Memorandum

TO: ERCOT AS Methodology Team

FROM: Jeff McDonald, Andrew Reimers

RE: IMM Comments on 2026 AS Methodology

Figure 1: Reserve Requirements Across Various US Electricity Markets

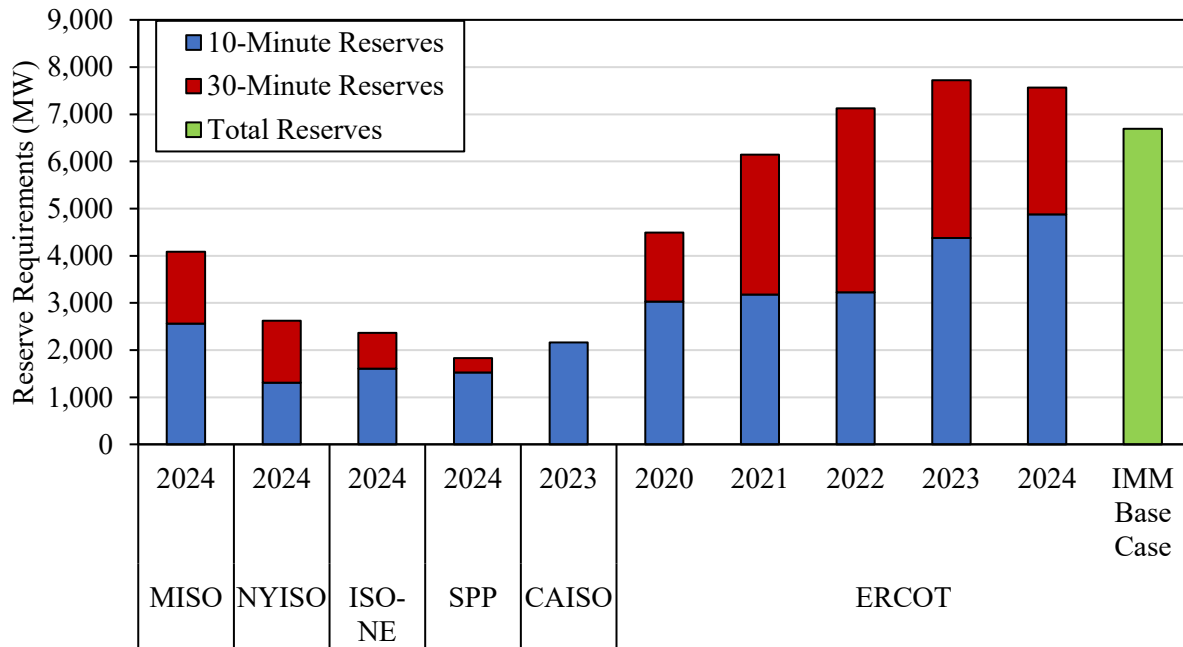
On average, ERCOT procures 153% more 10- and 30-minute reserves than other ISOs.

Figure 2: Annual Probability of Firm Load Shed and entering Watch Conditions*

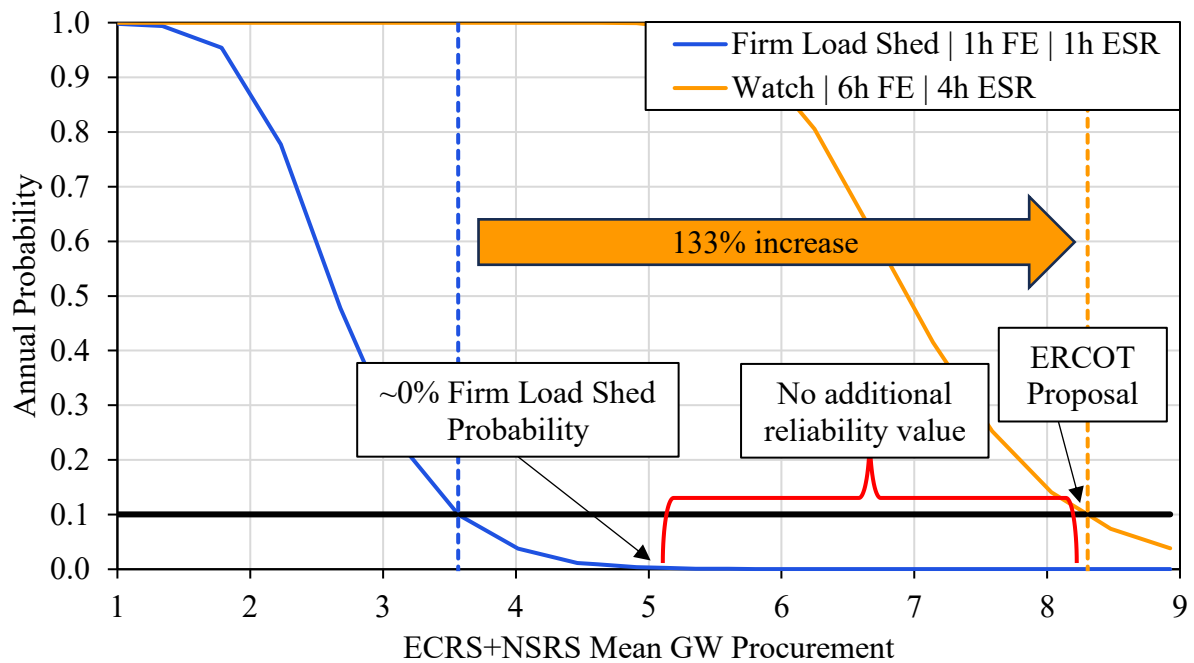
Together, these inputs result in the proposed AS Methodology that procures 133% more than what is required to satisfy the 1-in-10 reliability standard for load shed, *the last 3 GW of which provide no additional reliability*. This is illustrated in the following figure. The blue curve represents the probability of firm load shed at different procurement levels of ECRS and NSRS. This curve reflects the IMM base case and uses a one hour load forecast error and a one hour duration requirement for energy storage resources. The orange curve reflects the probability of entering a Watch condition at different procurement levels of ECRS and NSRS and uses the

ERCOT base case of a six hour load forecast error and a four hour duration requirement for energy storage resources. The procurement level required to achieve a one-in-ten (or 10%) probability of each outcome is identified by the intersection of horizontal black line with these two curves.

This figure shows that the level of total ECRS and NSRS needed to meet the one-in-ten (0.1 probability) reliability standard would average roughly 3.6 GW. In contrast, ERCOT's proposal would procure 8.3 GW of reserves, more than 3 GW of which would have no reliability value.

Together, this AS Plan is 133% larger than the IMM base case which achieves a 1-in-10 yearly probability of load shed. The last 3 GW of this plan provide no additional reliability value on average, as illustrated in Figure 1 (the same figure presented in the executive summary). We recommend that ERCOT revise their AS Methodology and consider operating reserve targets that reflect the reliability value they provide in mitigating real-time operational risks. The remainder of these comments detail our concerns with each of these parameters. A summary of the independent impact of each of these parameters on the size of the AS Plan is included in Table 1 at the end of these comments, and we include portions of Table 1 throughout.

- A 3-hour forecast horizon for determining the target volumes for NSRS.
- Using a 1-in-10 criteria based on the LOLP curve in place of the Watch criteria.
- Using a 1-hour discharge horizon for ESRs rather than 4 hours.

Figure 3: Annual duration of PRC less than 3,000 MW between 2016 and 2025

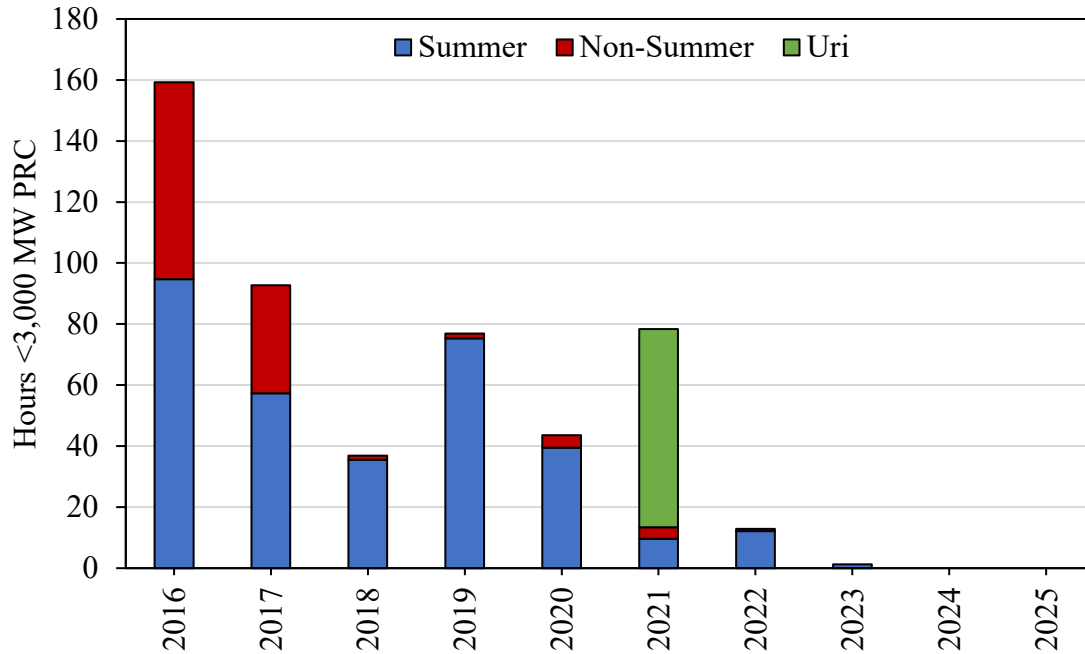
Prior to Winter Storm Uri, ERCOT had a policy of issuing a voluntary conservation notice referred to as a Watch whenever operating reserves dropped below 3,000 MW. Such events were relatively commonplace, with an average of 82 hours per year with PRC below 3,000 MW

for 2016-2020, as shown in Figure 2. The aftermath of Winter Storm Uri shone a spotlight on the reliability of the ERCOT grid and, given the recent legislative session and a gubernatorial election around the corner, it was decided that avoiding Watch conditions was of paramount importance. Thus, Conservative Operations was born, the primary feature of which was to run the system with a high level of operating reserves, whether procured through RUC or through the AS Methodology, as discussed in more detail in the following section.

Figure 4: Resource Availability Across Response Time Intervals

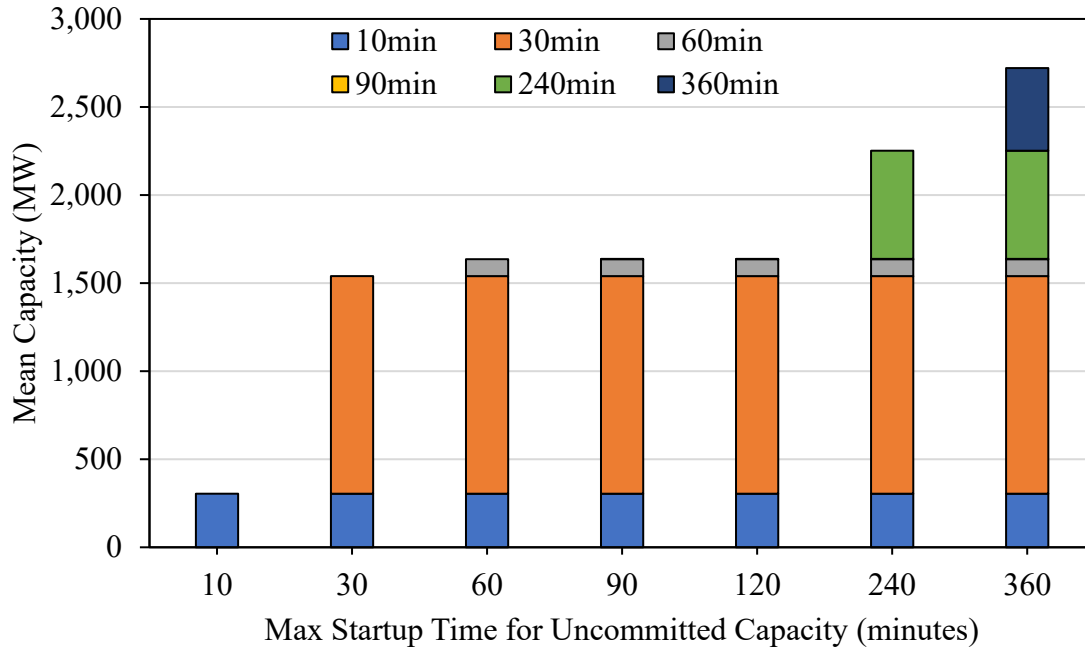
All inputs to the risk assessment should be based on the operational risks that the product is meant to manage. NSRS, for example, is designed to mitigate the risks associated with forced outages or forecast errors over a time horizon of approximately one hour. In the event of such risks manifesting themselves, market pricing should be sufficient to incentivize commitment of offline resources to maintain the reliability of the system. Our analysis has consistently shown that ERCOT has significant capacity from offline reserves that can start in an hour or less under tight system conditions, as illustrated in Figure 3. These conditions produce higher prices which in turn elicit a market response of self-commitment from available off-line resources. Setting this parameter to six hours nearly doubles the perceived risk associated with forecast error, as shown in Figure 4. This parameter effectively assumes that none of the offline capacity will self-commit in response to evolving system conditions, which is contrary to historical experience.

The cumulative capacity of reserves available to start under tight system conditions (PRC < 5,000 MW) includes more than 1,500 MW of capacity capable of starting in an hour or less.

Figure 5: Net Load Forecast Error Across Different Time Horizon Durations

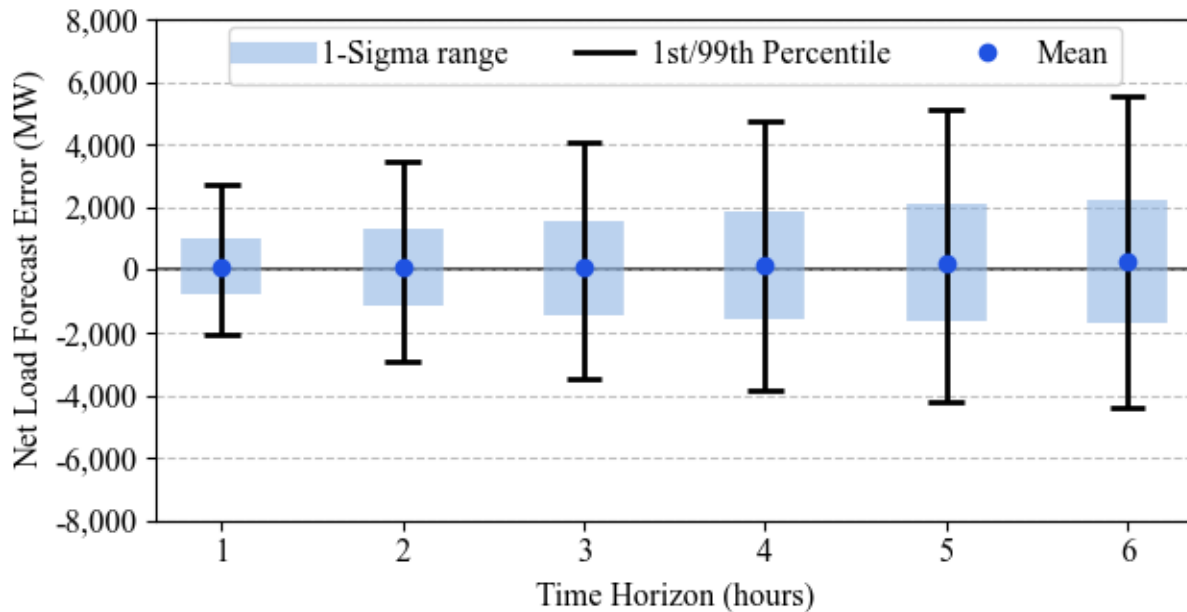
ERCOT's operational history demonstrates that six hours is an unnecessarily long time-horizon to run the system reliably. From 2016 to 2022, the methodology for determining the target volumes for NSRS used a three hour ahead forecast error. Over that time, there was no firm load shed caused by a lack of sufficient NSRS.

Forecast error risk is nearly twice as high six hours ahead as one hour ahead, ignoring the likelihood of self-commitment from quick-start resources.

Figure 6: RUC Commitments Between 2016 and 2024

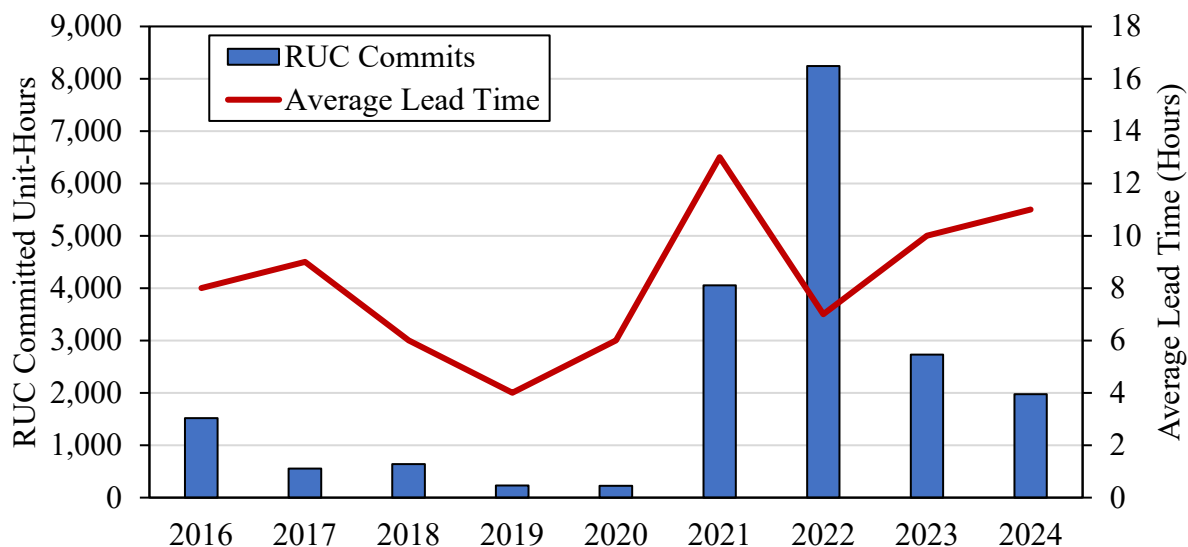
Figure 6 shown in the following section shows the increase in the unit hours of resources committed through RUC and the increase in the average lead time between the commitment instruction and real-time. The following year, to achieve its desired level of operating reserves through the market rather than through overreliance on RUC, ERCOT increased the time horizon used for calculating forecast error in the NSRS methodology to six hours. Thus, *the methodology followed from the operational paradigm*, which itself was not supported by sound reliability criteria.
